SIB 66 13 23

CAMERA-BASED ADAS: CCM FOR RESTRICTED FUNCTION – KAFAS CAMERA HOOD DEFORMATION

2025-10-29

This Service Information bulletin (Revision 1) supersedes SI B66 13 23 dated September 2023.

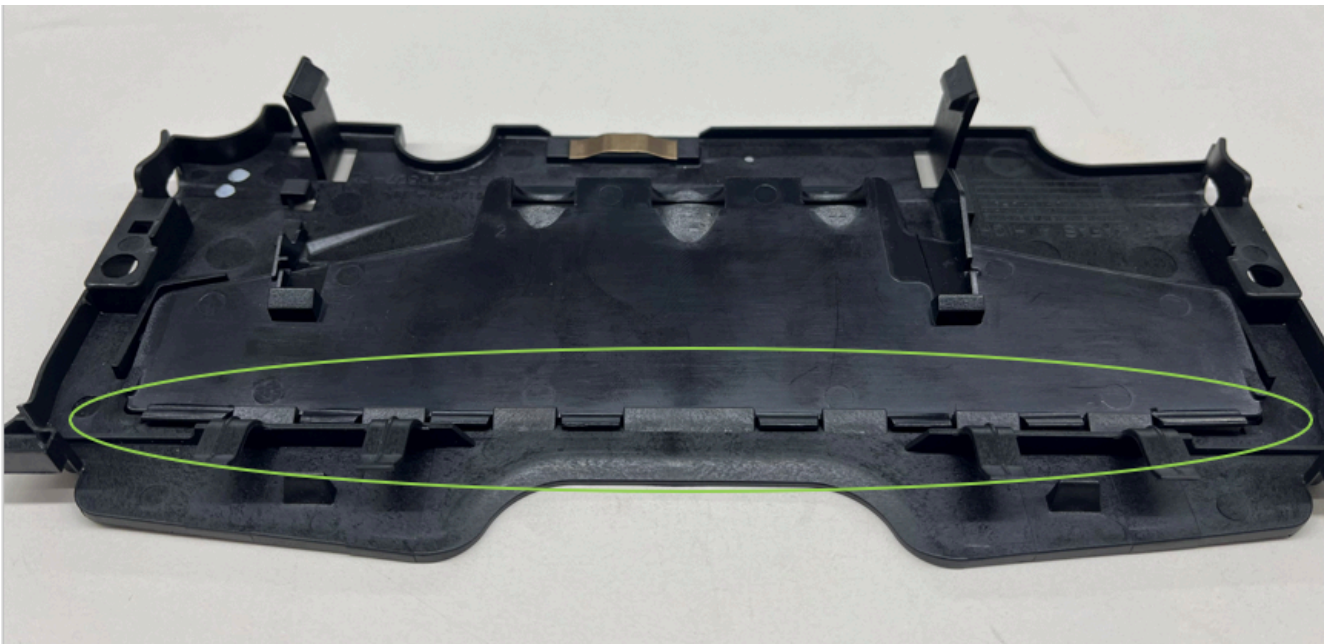
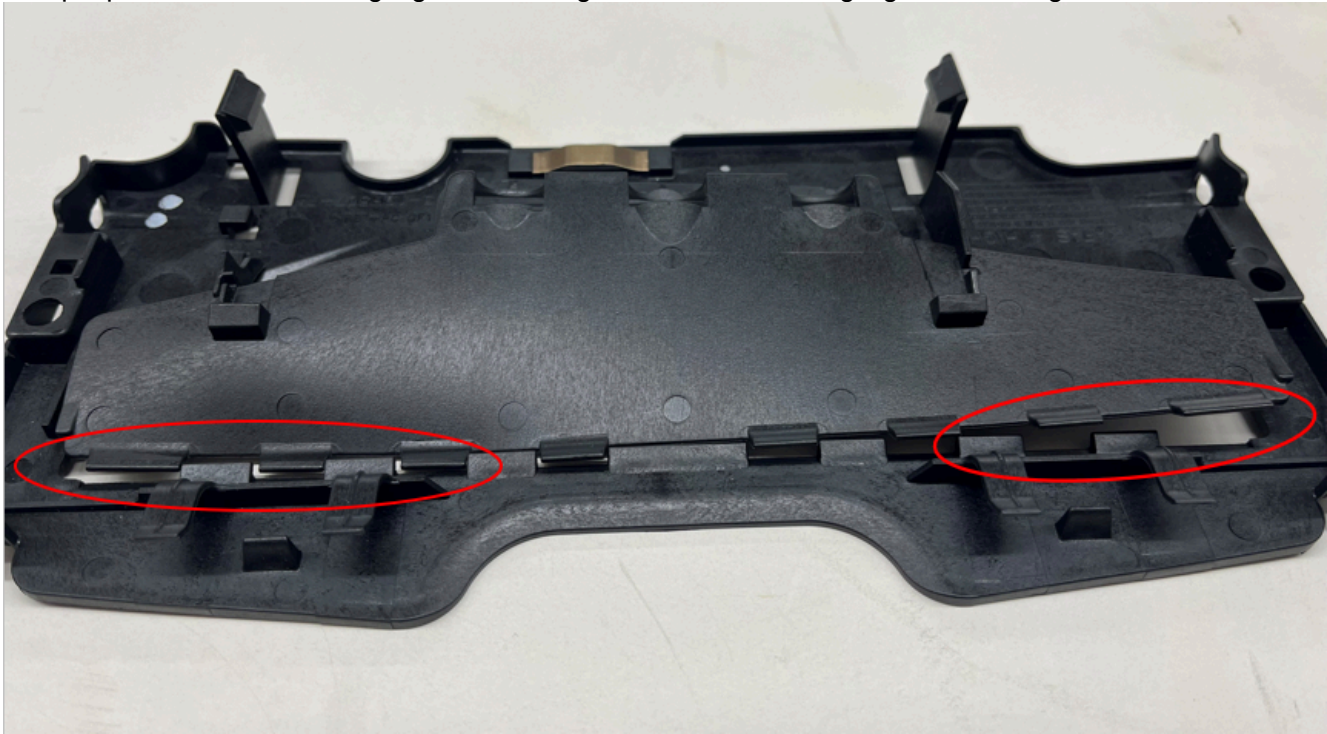
The KAFAS 4 High camera reaches temperatures that the KAFAS camera hood material cannot withstand. This results in deformation/distortion of the KAFAS camera hood.

2. When installed, check whether the KAFAS hood is in contact with the holder/mount all the way around. See example photos below. **Red** highlighted showing distortion. **Green** highlighted showing no defect.

If you find distortion, replace the KAFAS camera hood with part number 51 31 5A93179 for (F97 G01) front windscreen trim or part number 51 31 5A9A552 for (F98 G02). Then follow the below modification steps.

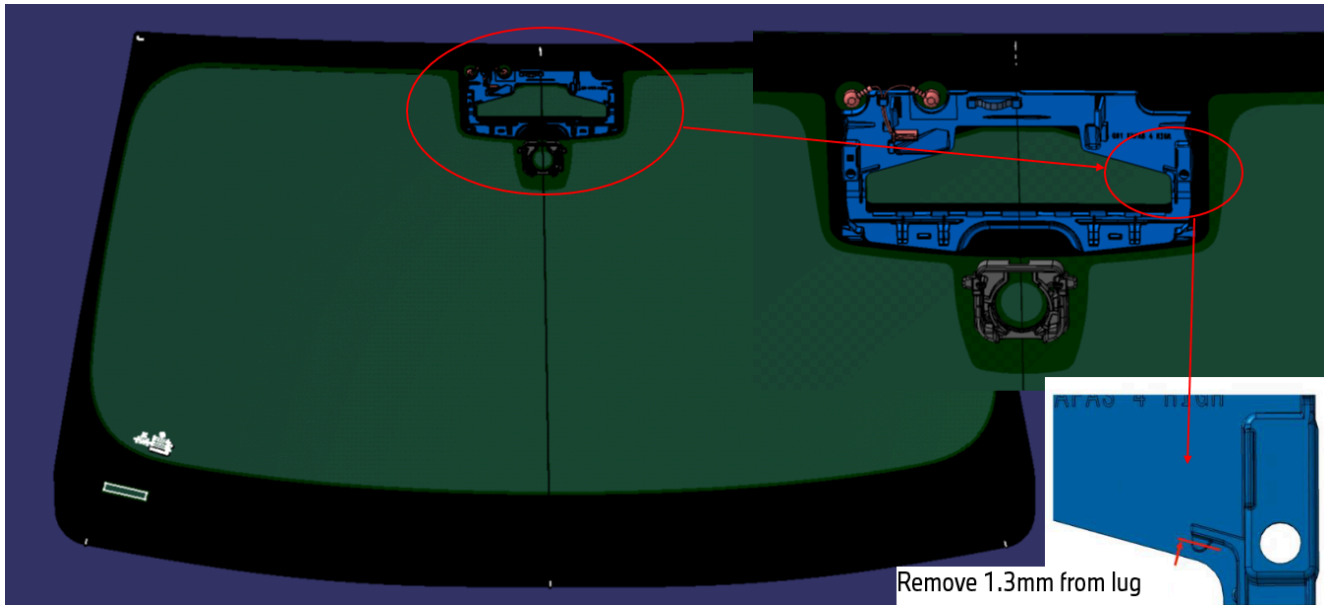
3. Remove the interior mirror trim, the interior mirror, the KAFAS camera and the KAFAS camera hood so that access to the retaining lug shown at the bottom right of the example photo is ensured.

The mounting point for the KAFAS camera hood must be adjusted.

Using a grinding tool (for example Dremel®), shorten the entire surface of the retaining lug by 1.3 mm. See example photo with location for modification. Then deburr and clean it thoroughly, and remove the adhesive tape.
